Item Name: Aft Tube Assembly

Draw Nbr	Revision Nbr
D3391	Rev H/ DEO

DRAWING NO.	TITLE	REV. H	DART AEROSPACE USA, INC	D.E.O. NO.	SHEET NO.	SCALE
D3391	412 FLOAT SKIDTUBE		ENGINEERING ORDER	D3391-H-1	SHEET 1 OF 1	NTS

PURPOSE:
LPS-3 IS NO LONGER USED DURING ASSEMBLY OF D3391-041/-043 SKIDTUBES.

D3391-041 ASSEMBLY

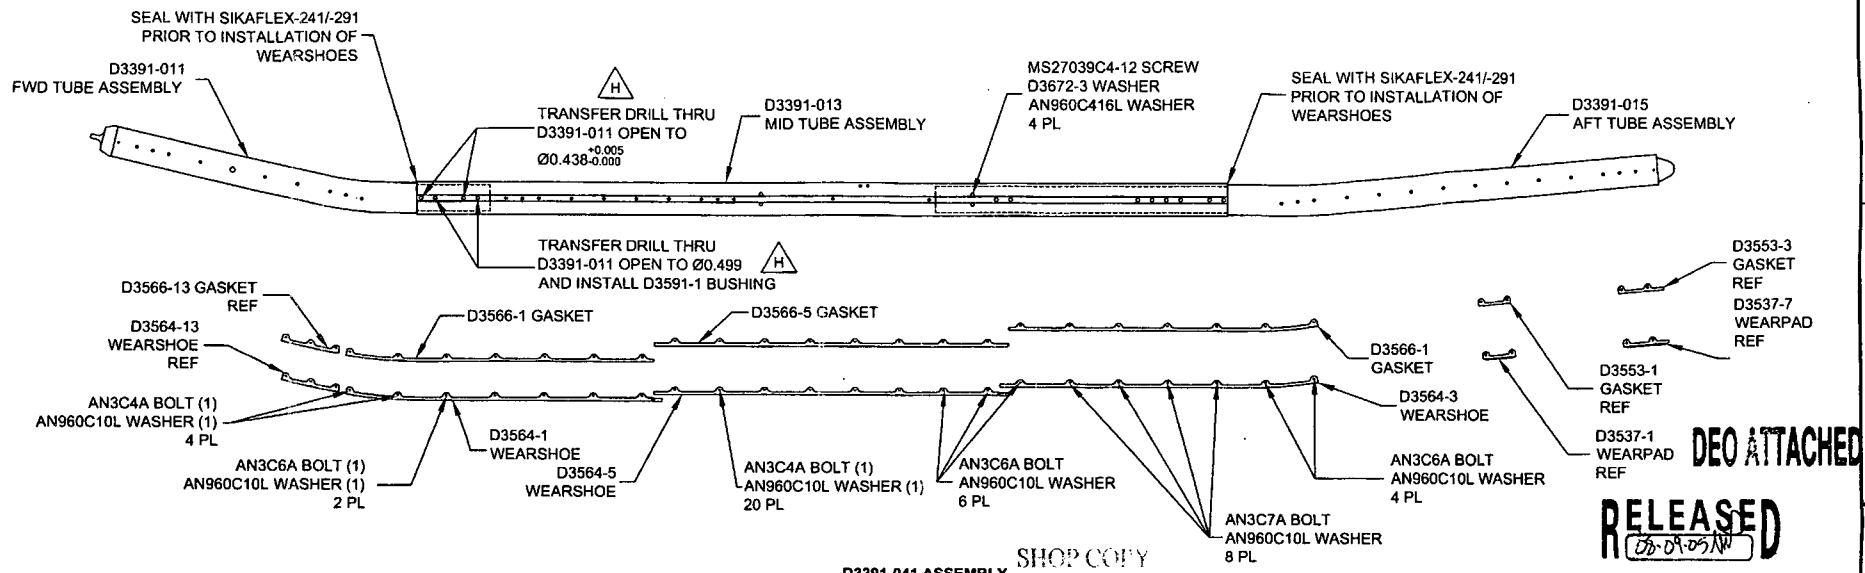
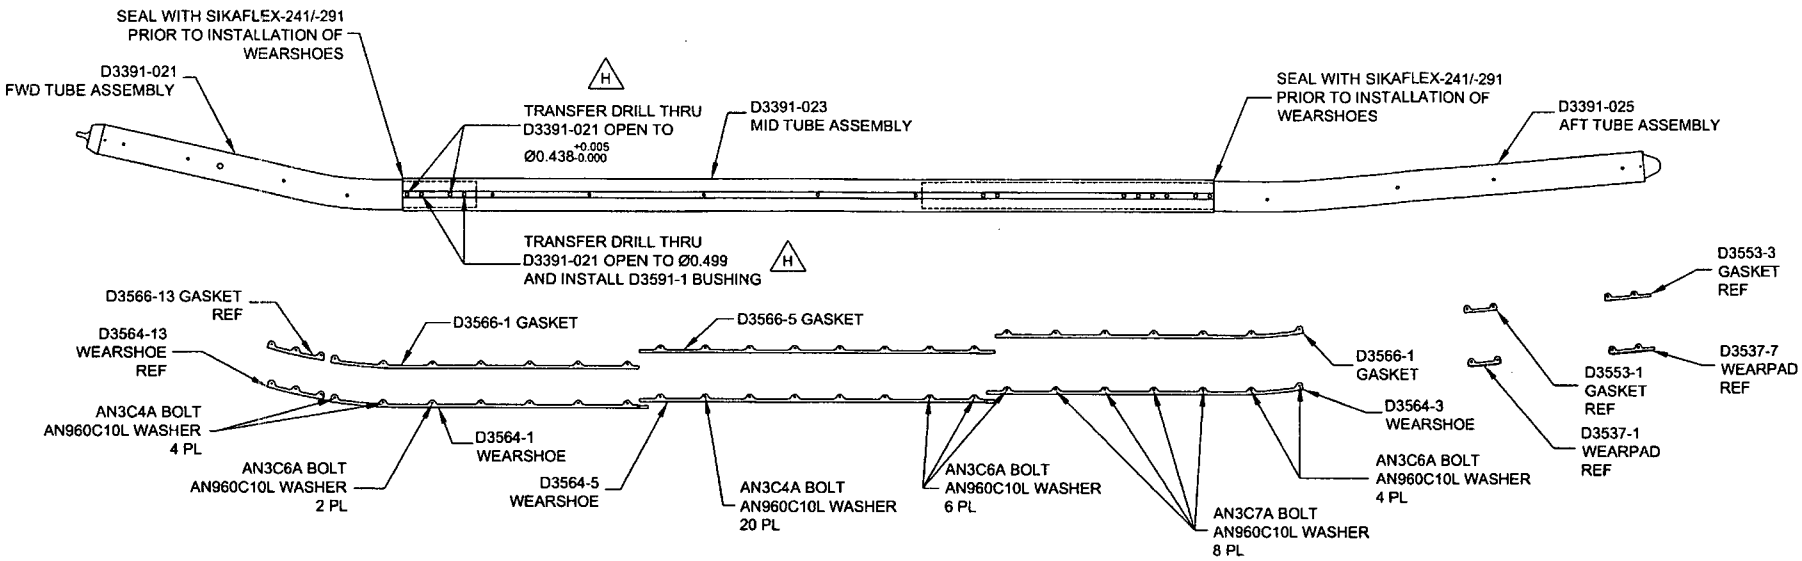
CHANGE:
AMEND NOTE 2 OF D3391-041/-043 SKIDTUBE ASSEMBLIES (ZN A6-1, A6-2) AS FOLLOWS:

2) ~~SPRAY INSIDE OF TUBE WITH A COAT OF LPS LABORATORIES "LPS-3" AFTER FINISH AND AFTER INSTALLATION OF INSERTS.~~ COAT ALL EXPOSED FASTENERS WITH LPS LABORATORIES "LPS PROCYON" AFTER FINAL ASSEMBLY, CLEAN EXCESS OFF POWDER COATING WITH MEK DEGREASER.
